## CITY OF VANCOUVER

### POLICY REPORT DEVELOPMENT AND BUILDING

TO: Vancouver City Council  
FROM: Director of Current Planning  
SUBJECT: CD-1 Rezoning - 2330-2372 Kingsway and 2319 East 30th Avenue

Drawing:  
Kingway (North) Elevation

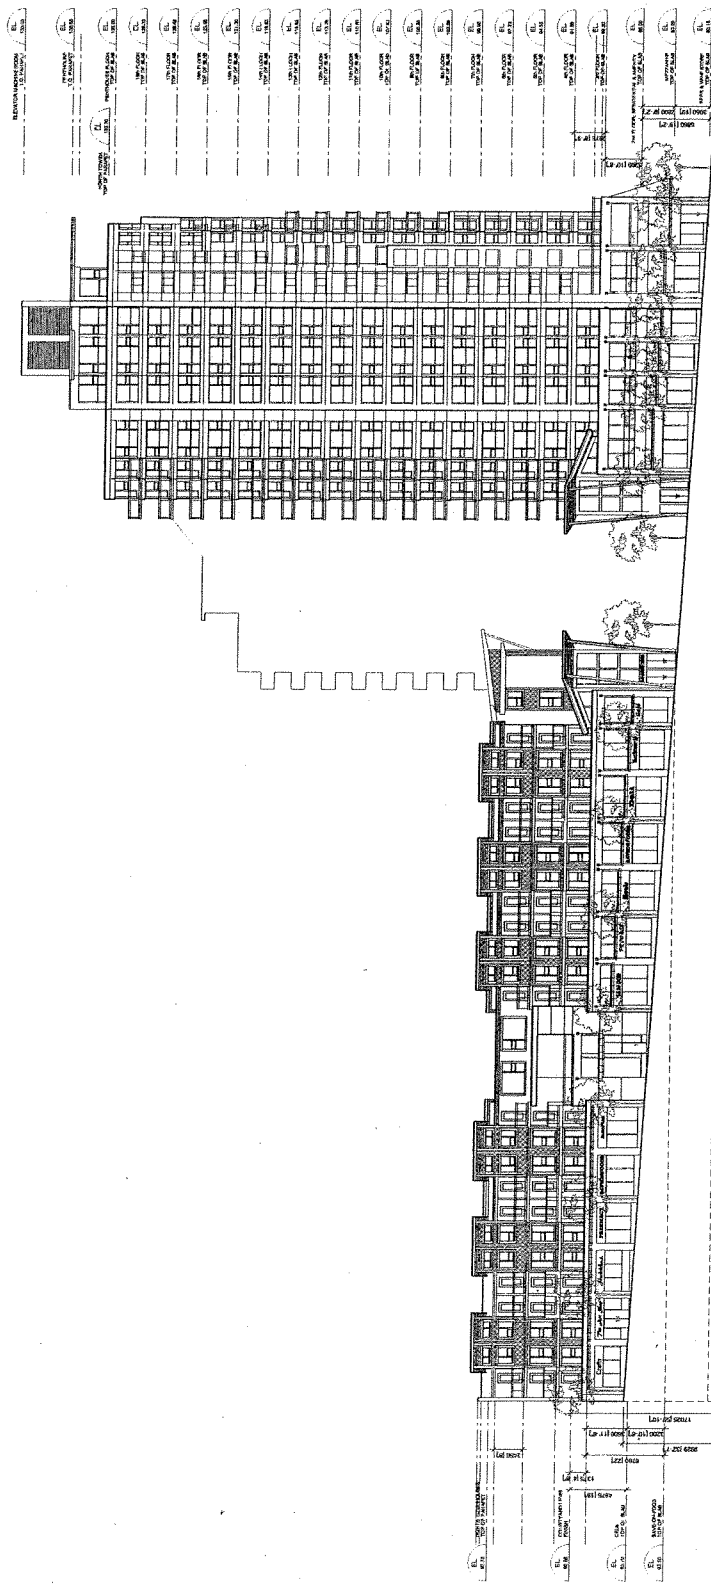
In the northeast corner of the site, the proposed 4 storey building fronting onto Kingsway would also benefit from an increased scale to provide prominence and presence on this important street and relate better to the corner tower form. Staff suggest that an increase to 6 storeys would have no significant shadow or view impacts given the wide Kingsway right

- (17) provide a 0.6 m (1.97 ft.) building setback on Kingsway at the east end, increasing to a 1.2 m (3.94 ft.) building setback from the westerly side of the residential entrance to the new access driveway;
- (18) design development to provide a strong sense of street enclosure on Kingsway by increasing the massing to 6 storeys;

Project:  
No. 0372  
Kingway & Nanaimo  
Vancouver, BC  
Drawing:  
Nanaimo (West) Elevation

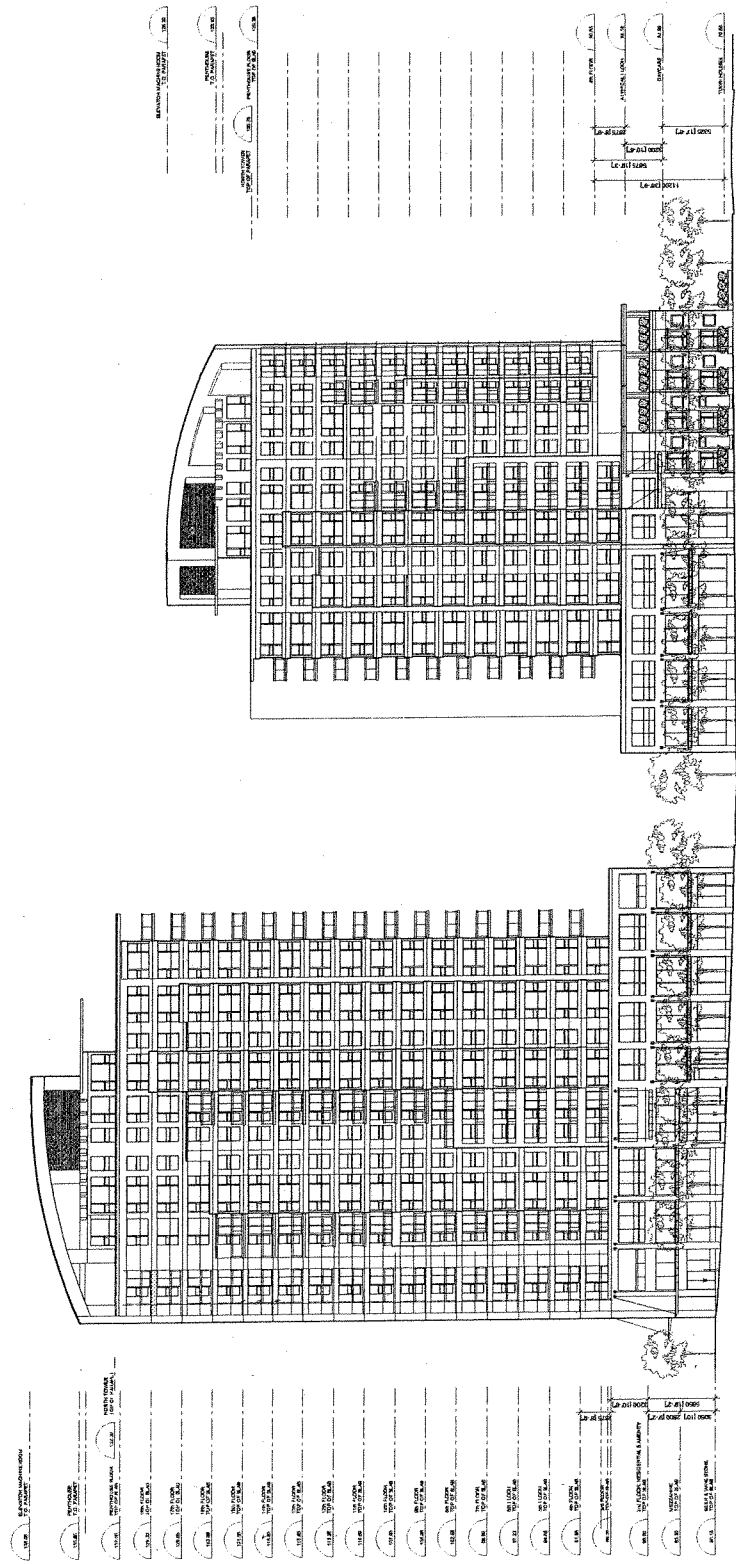
However, staff recommend several design development improvements to the massing of the proposal. The second tower, located in the southwest corner of the site, fronting onto Nanaimo Street should be reduced from a height of 15 to 7 storeys to better relate to the surrounding, lower scale residential development. In contrast, the 19-storey tower in the northwest corner of the site should be increased to 22-storeys to create a significant tower form at the intersection of Kingsway and Nanaimo Street.

- (25) design development to reduce the height of the building to a maximum height of 23 m (75.5 ft.) and 7 storeys, including the child day care level;
- (26) provide a 3.6 m (11.8 ft.) setback and universal access to the ground level residential use from the street, and internal corridor access for ground level units on the mews, East 30th Avenue and Nanaimo Street to facilitate flexible conversion to artist live-work studios;
- (27) provide a second row of street trees inside the property line along Nanaimo Street and East 30th Avenue;
